Westinghouse Electric Company
Nuclear Services
P.O. Box 355
Pittsburgh, Pennsylvania 15230-0355
USA

Your ref:
Our ref: LTR-NRC-02-60

Subject: Response to RAI on the "Topical Report on Modular Accident Analysis Program Version 5 (MAAP5) Pressurized Water Reactor (PWR) Large Dry Containment Model," WCAP-15844

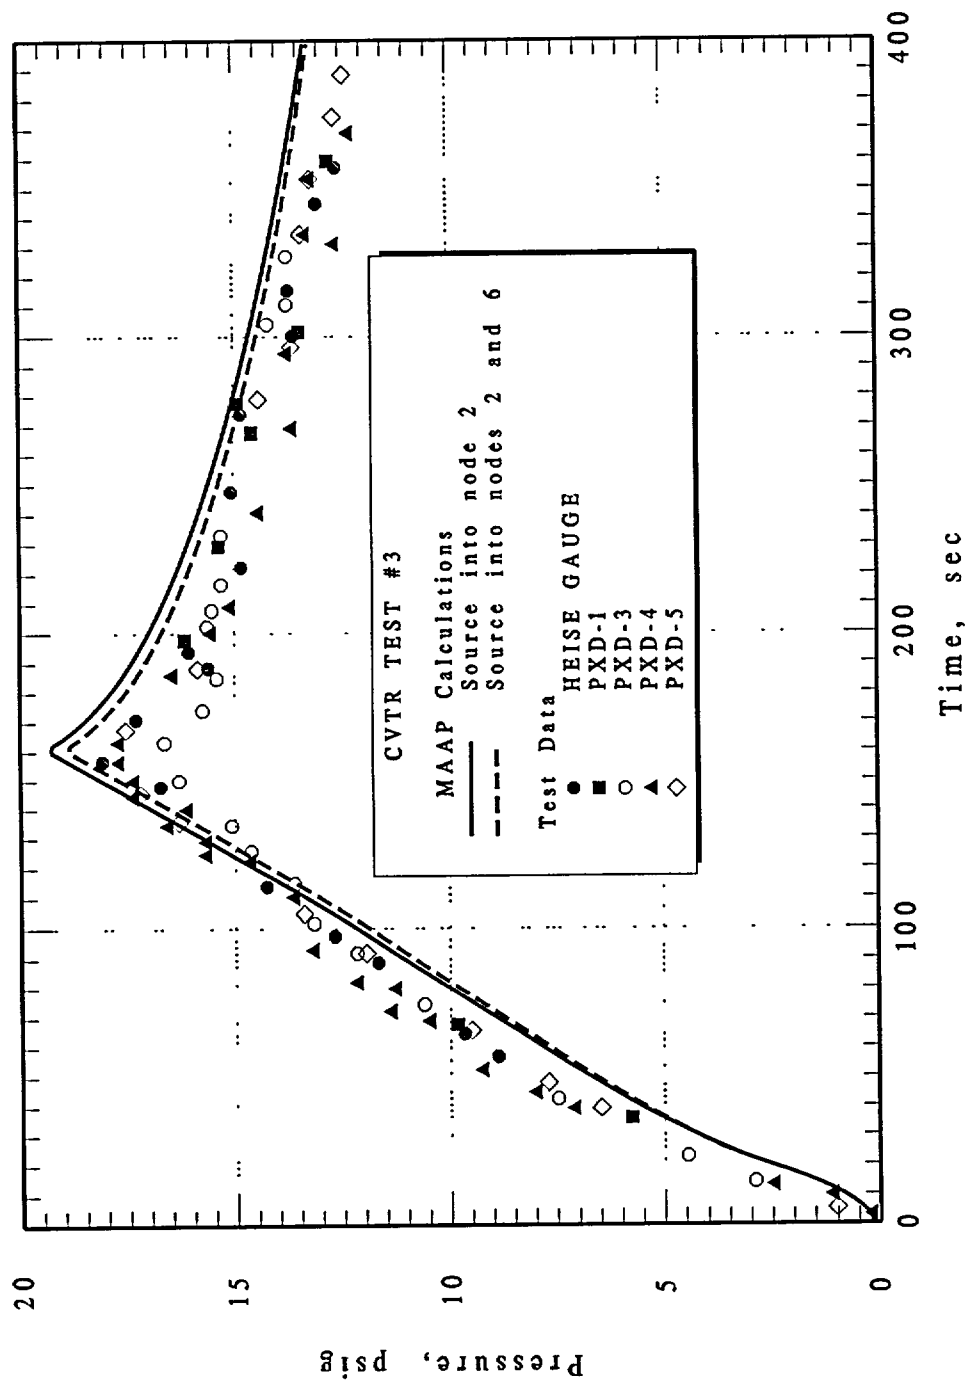
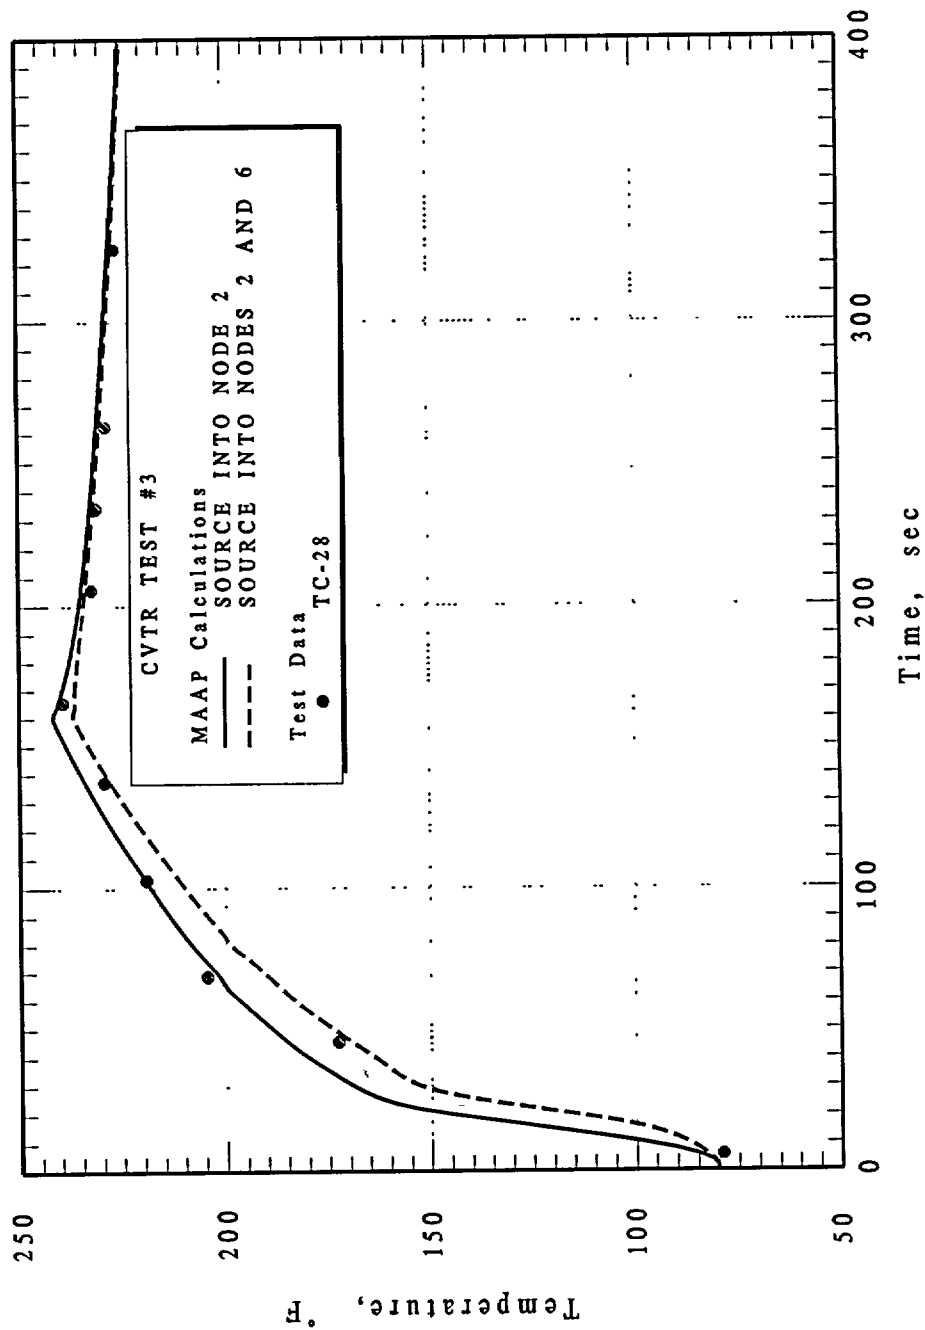
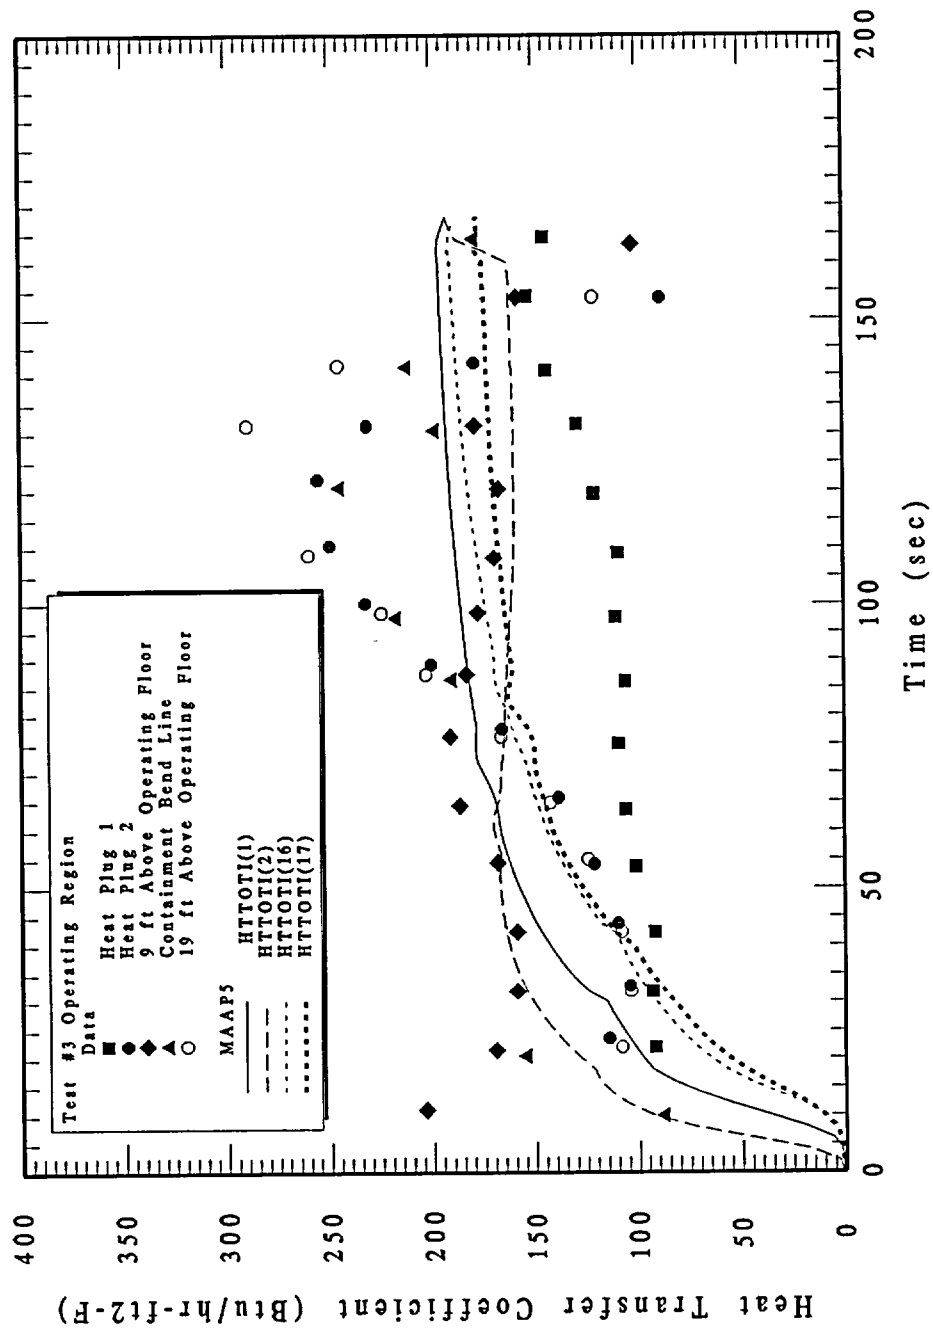
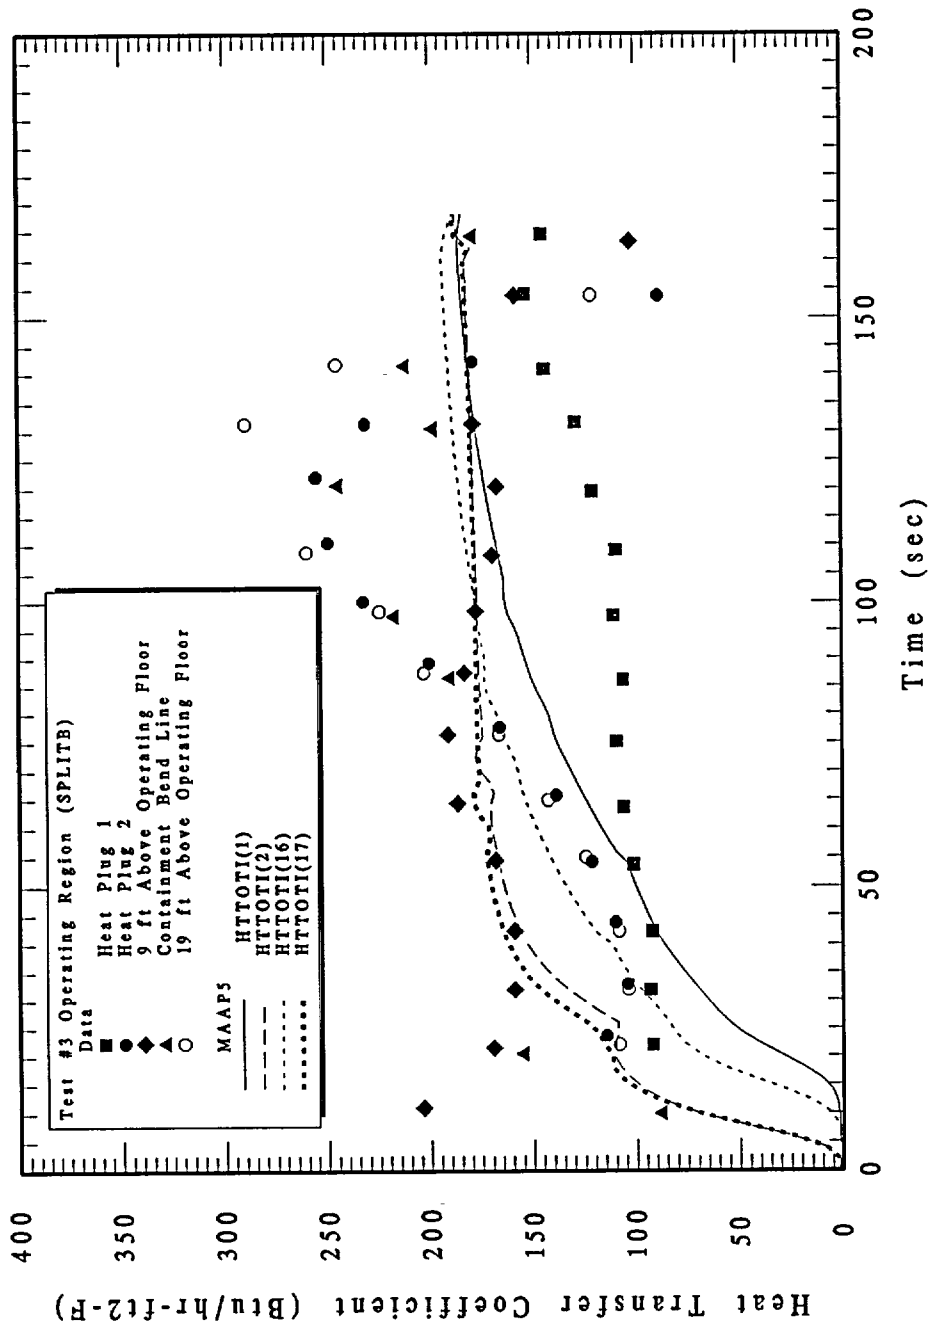
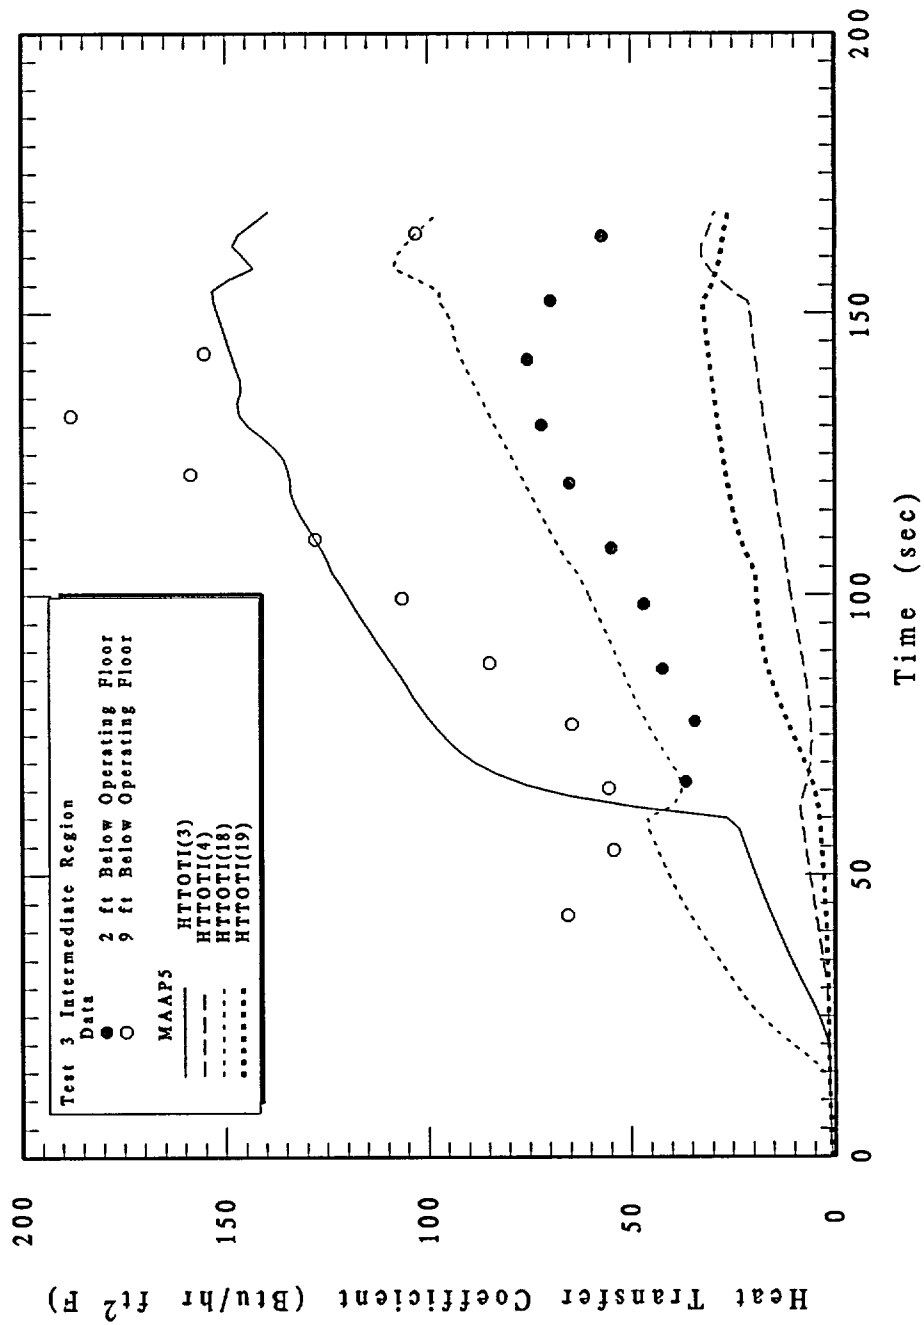
Item 2.2.10. Provide a comparison of CVTR heat plug #2 heat transfer coefficients calculated for the MAAP uncertainty parameters.

The information provided in the CVTR experimental report includes calculations of the overall heat transfer coefficients at two heat plugs. Thermocouple measurements in the instrumented plugs enabled the authors to deduce the effective time dependent surface heat transfer coefficients. Comparisons are provided below for the MAAP5 calculated surface heat transfer coefficients in the nodes above, and below, the operating deck.

As described in the experimental report, steam was introduced above the operating deck through a 10 inch diffuser pipe (numerous small holes) to discharge the steam in several directions. CVTR has been analyzed assuming that the steam was discharged into a single node above the operating deck (node 2 of the 12 node MAAP5 containment model). Additionally, the response has been analyzed assuming that the steam was discharged equally into nodes 2 and 6 (both nodes are immediately above the operating deck). Figure 1 shows the containment pressure responses using these two assumptions with the associated temperature responses being shown in Figure 2. Only small differences are calculated in the global response of the containment peak pressure and temperature.

The Heat Transfer Coefficients (HTCs) deduced through the heat plug measurements, as well as those HTCs deduced from the measured temperatures on the inside and outside of the containment liner, are compared (Figure 3) with the MAAP5 calculated values when the mass and energy release is discharged only into node #2. Figure 4 compares the same quantities when the mass and energy release is simultaneously discharged into nodes 2 and 6. In these figures heat transfer coefficient $HTT_{OT}(1)$ is for the containment wall heat sink in node 1, $HTT_{OTI}(2)$ is the calculated heat transfer coefficient to the wall in node 2, $HTT_{OTI}(16)$ is the heat transfer coefficient to the containment wall in node 5 and $HTT_{OTI}(17)$ is the heat transfer coefficient to the containment wall in node 6. The calculated and measured heat transfer coefficients are in agreement.

Heat transfer coefficients deduced for local temperature measurements are also reported for regions immediately below the operating floor and for the basement region. These are compared to the MAAP5 calculated values in Figures 5 and 6 for mass and energy release discharged into node #2. In these two figures, $HTT_{OTI}(3)$ is the wall heat transfer coefficient in node 3, $HTT_{OTI}(4)$ is the heat transfer coefficient in node 4 with $HTT_{OTI}(18)$ and $HTT_{OTI}(19)$ being the respective heat transfer coefficients in nodes 7 and 8 which are diametrically opposed to nodes 3 and 4. Correspondingly, the variable $HTT_{OTI}(5)$ is the heat transfer coefficient in node 11, which is at the bottom of the containment building and variable $HTT_{OTI}(20)$ is the heat transfer coefficient in node 12 which is diametrically opposed to node 11. Here also there is agreement between the measured and calculated values in both regions.
